# PSB INJECTION LINE

# L4 Project meeting

- The LINAC4 machine and the PSB had their own review several years ago. The part between LINAC4 and the PSB was never reviewed.
- During the construction of the LINAC4 building a new LINAC2 building wall has been discovered with a direct impact on the position of quadrupoles and instrumentation of the transfer line.
- A designer to start working at the beginning of 2011 is strongly desired in order to be ready for installation at the end of 2012.
- C. Carli has kindly accepted to take the responsibility of the transfer line as from January 2011.

## PRESENT LIMITS OF TRANSFER LINE LINAC4/PSB:

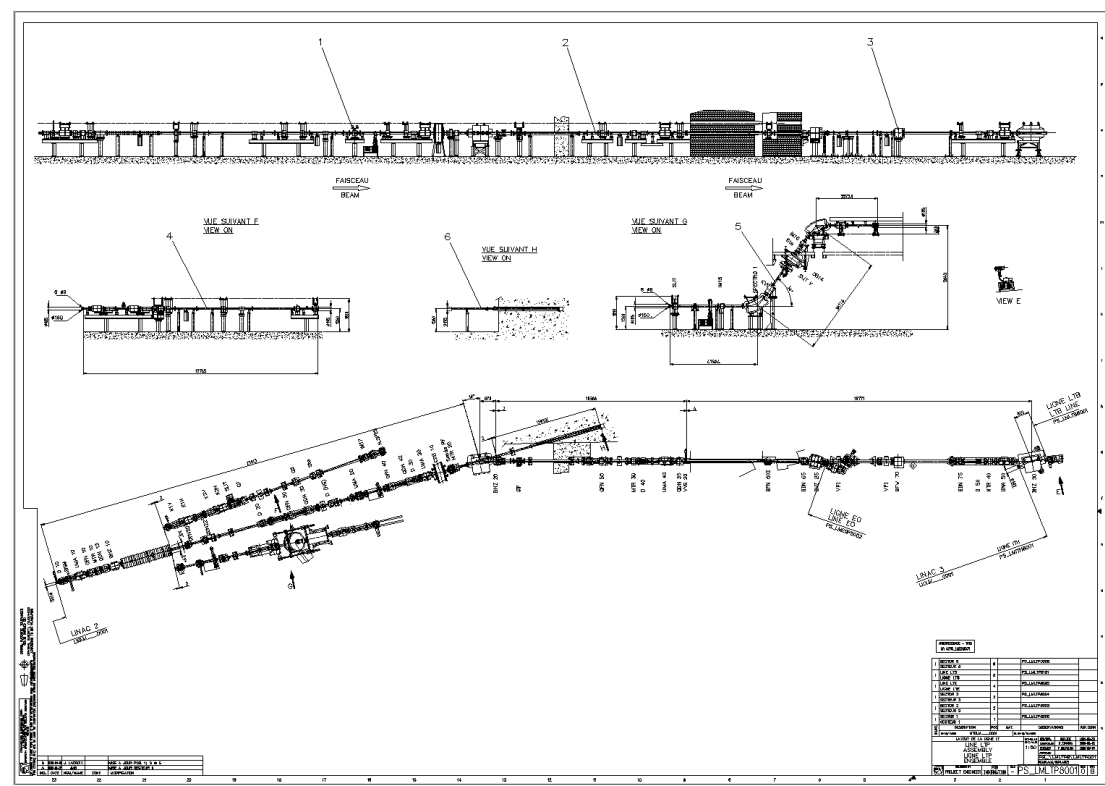
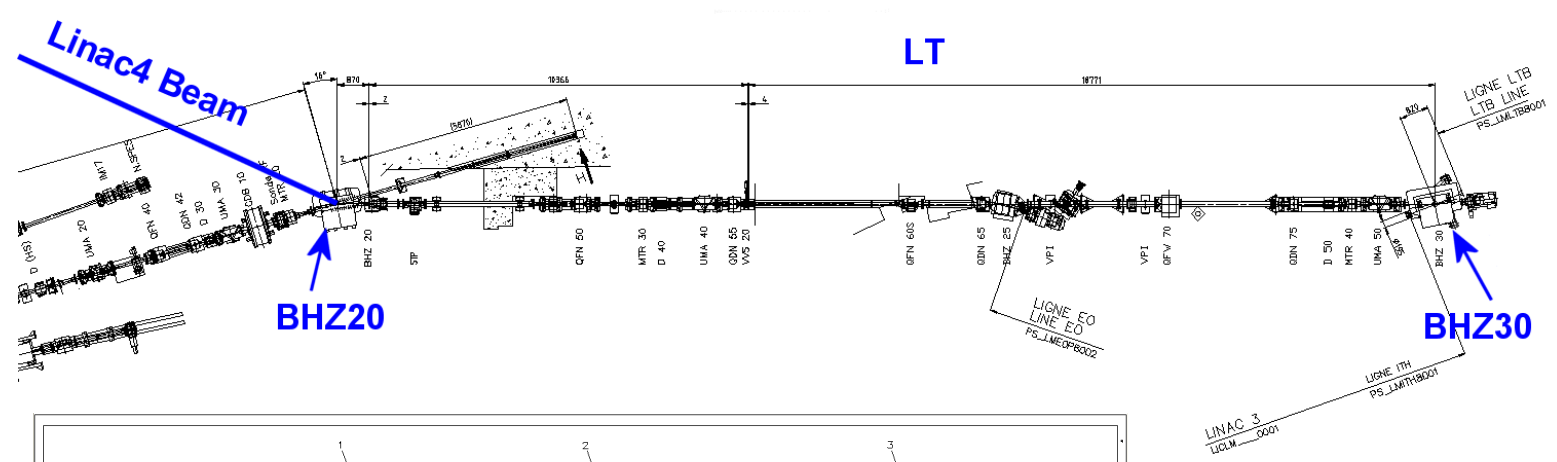
No reason to have a common boundary at the distributor flange:

1. zoning (common line would extend over 2 access zones).
2. coordination responsibility.
3. control system and naming (existing limit LTB/BI).
4. elements bw. present boundary and distributor are used by the PSB operators for matching to PSB and alignment on distributor.

In any case, linac beam optics goes further than the distributor...

# Measure ment lines LBE, LBS

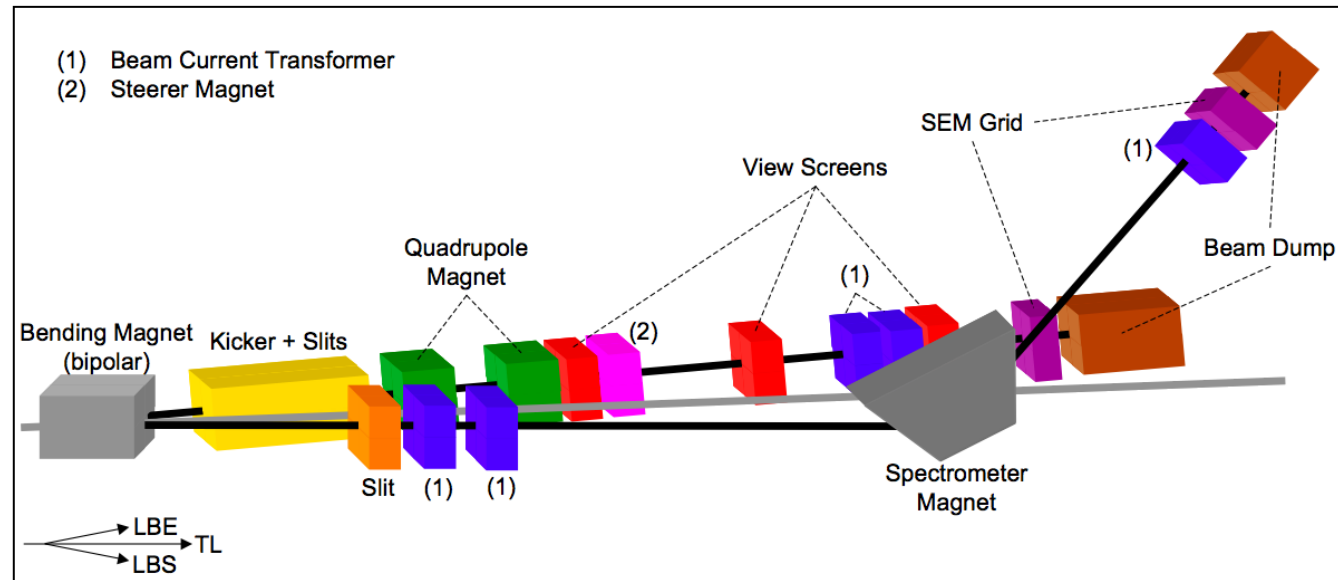
- Still to be done before installation:
  - Final screen and camera design (same as for Linac4 dump line), equipment and support drawings and layout.
  - Add water-cooling to quadrupoles, exchange power converters

- Move steerer dipole.
  - Dump design.
  - Beam pipes.
- **LBS:**
  - Layout proposed, compatible with ion operation. To be adapted in case slit dimensions and equipment positions (dump!) change.

- Laser scanning done to prepare an integration drawing.
- Still to be done before installation:
  - Propose slit and dump designs, check compatibility with RP restrictions.

- Finalize SEM grid and spectrometer magnet specifications.
  - Integration drawings needed in addition to layout drawings.
  - Prepare software application.

- Solve problem of lifting existing/new equipment over BI line.
